#2015-16
Bucky's Convenience Store – Preliminary and Final PUD and Special Use Permit
Project Review for Planning and Zoning Commission

Meeting Date: April 22, 2015

1. Rezoning from E to B-2 PUD
2. Preliminary and Final PUD
3. Special Use Permit to allow a Gasoline Service Station and Convenience Store with a Gasoline Electronic Pricing signs.

Location: 8108 Pyott Road

SIGN 1

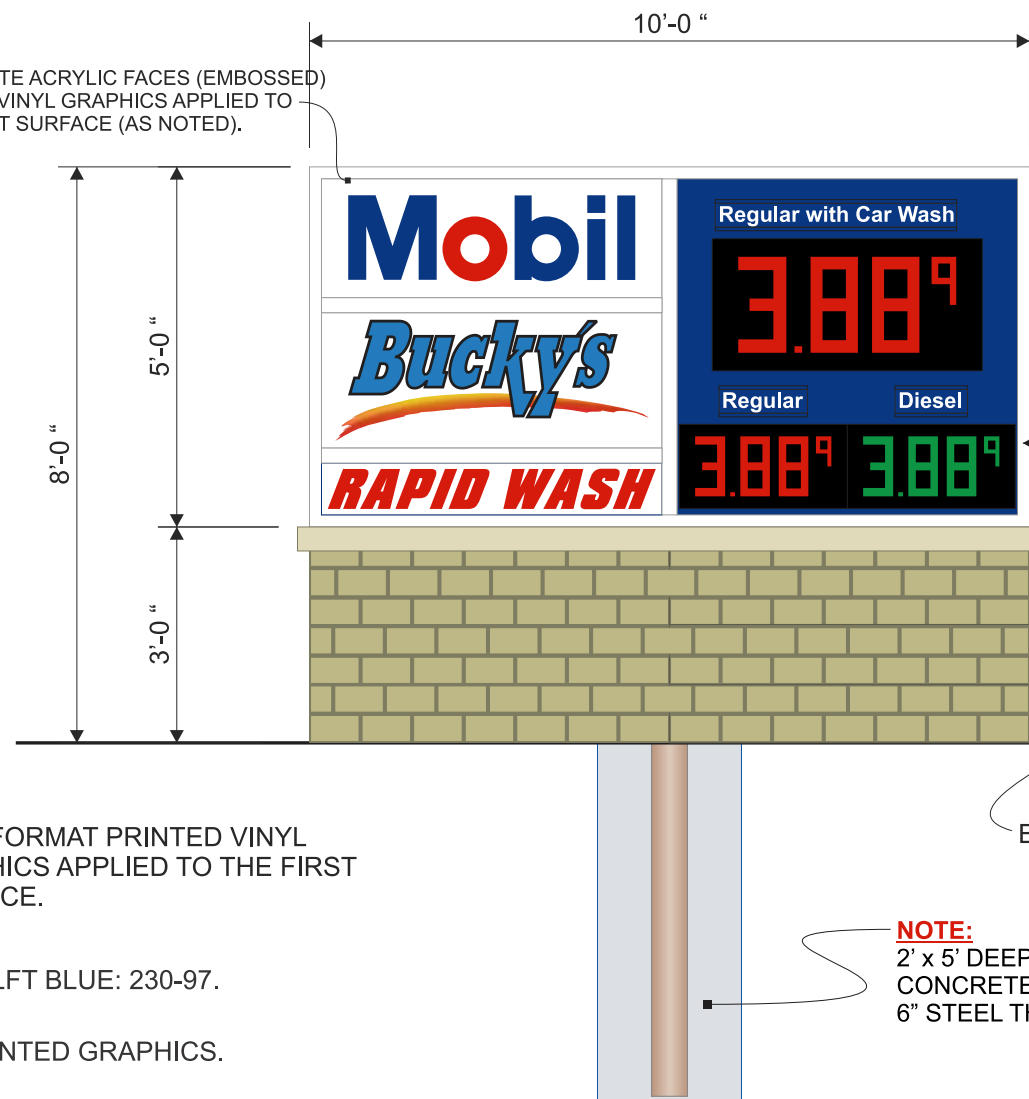
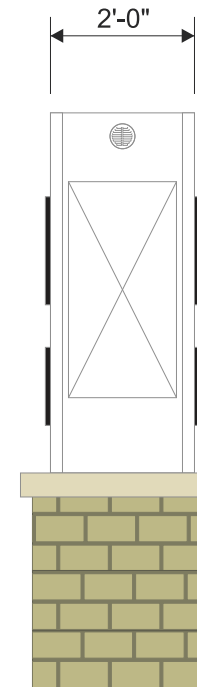
- The petitioner is proposing 2 free-standing electronic pricing signs one to be located along each roadway. The proposed illumination is red, which requires a variation. The size, height and location meet all ordinance requirements.

CRYSTAL LAKE, ILLINOIS
FRONT ELEVATION

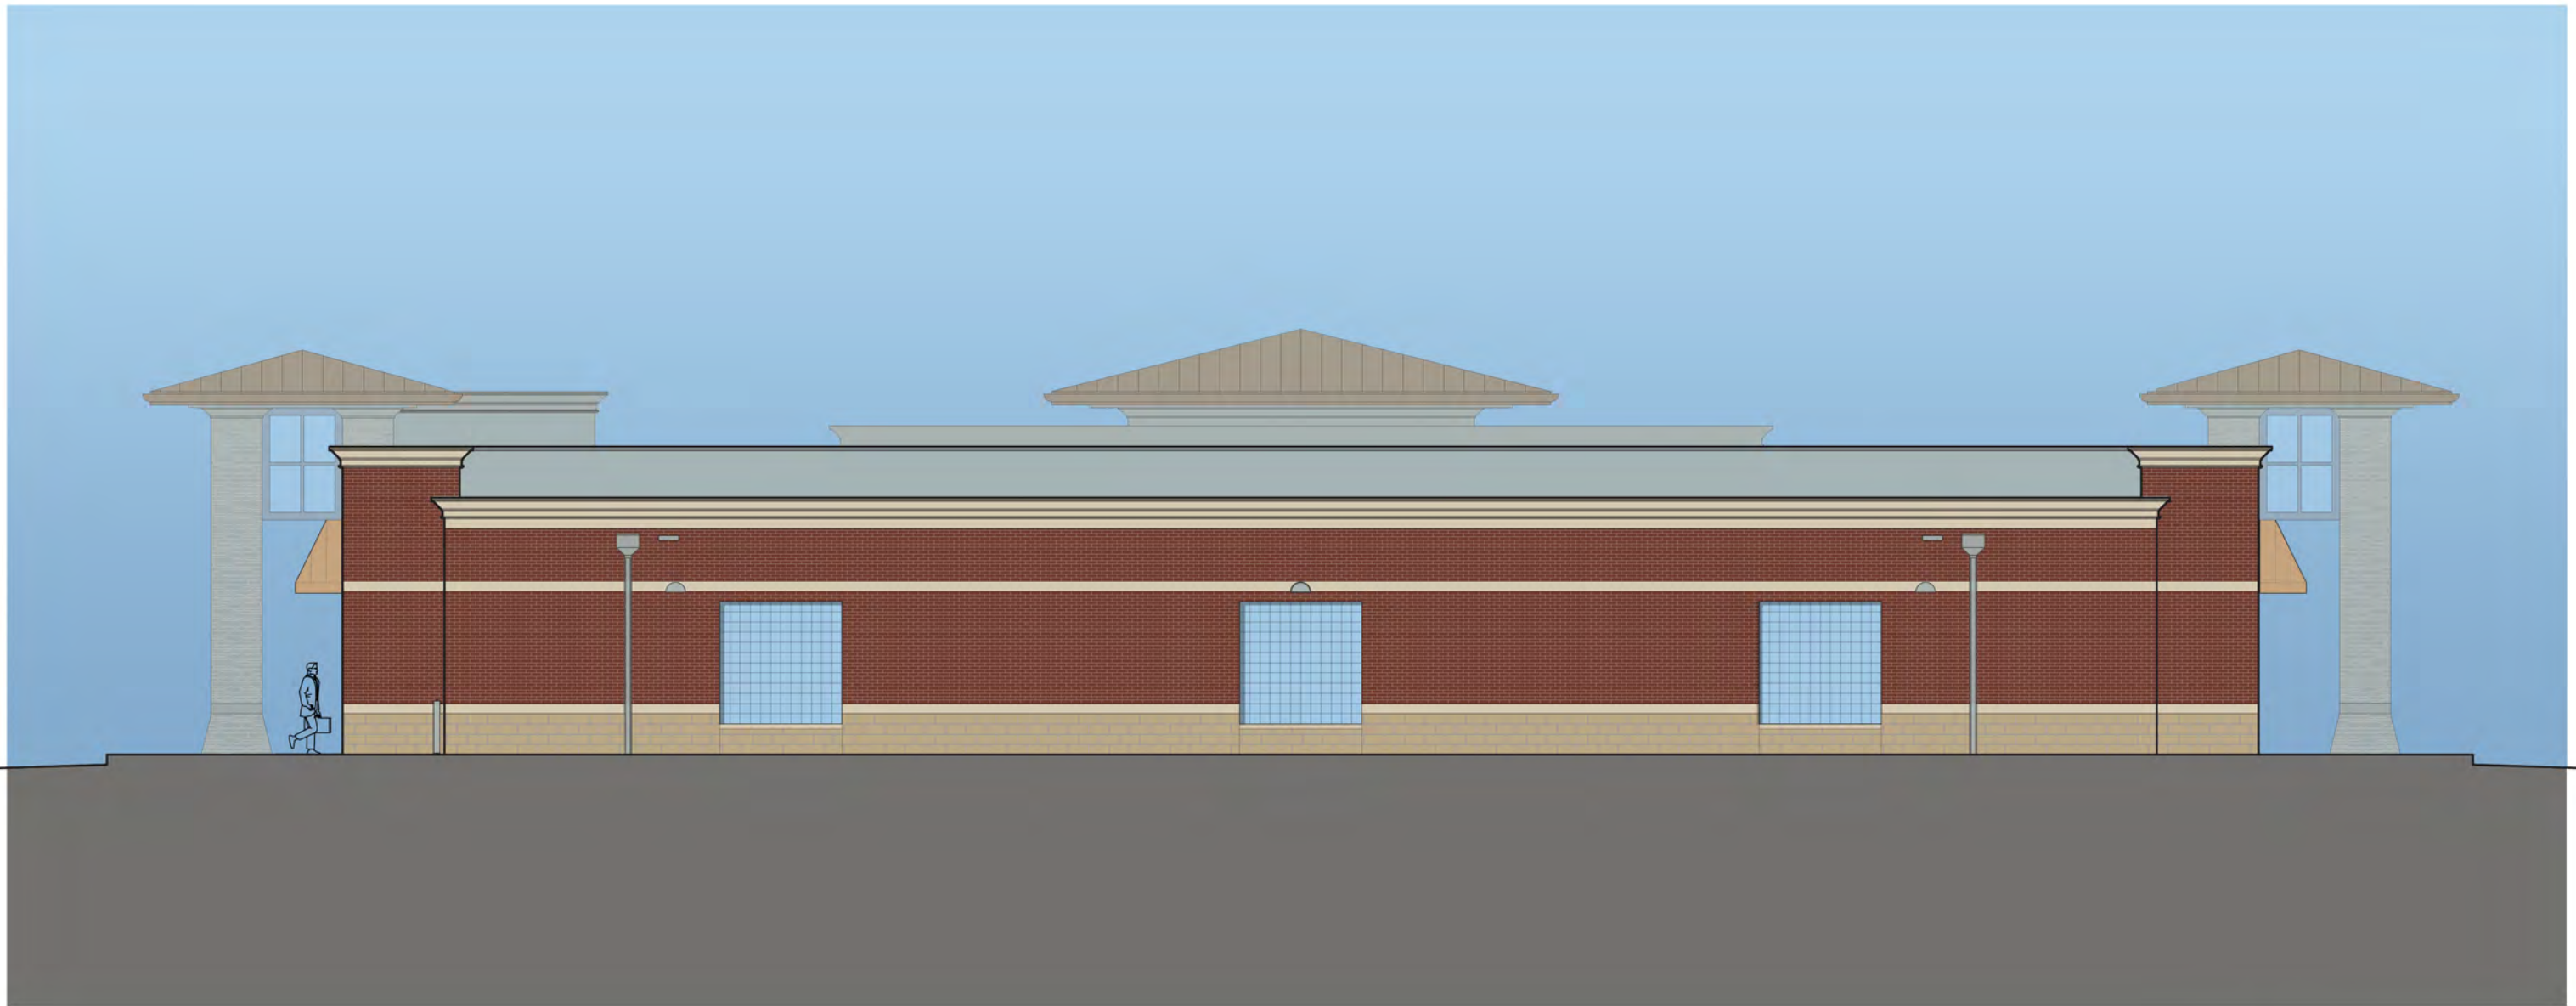
- The signage on the convenience store is broken up on the three main facades. The front elevation has 96 sq. ft., the left elevation has 31 sq. ft. and the right elevation has 34 sq. ft. This is a total of 161 sq. ft.

The building meets all the criteria under this category except for the minimum 2-foot stagger. There is a 1-foot stagger provided along the front elevation.
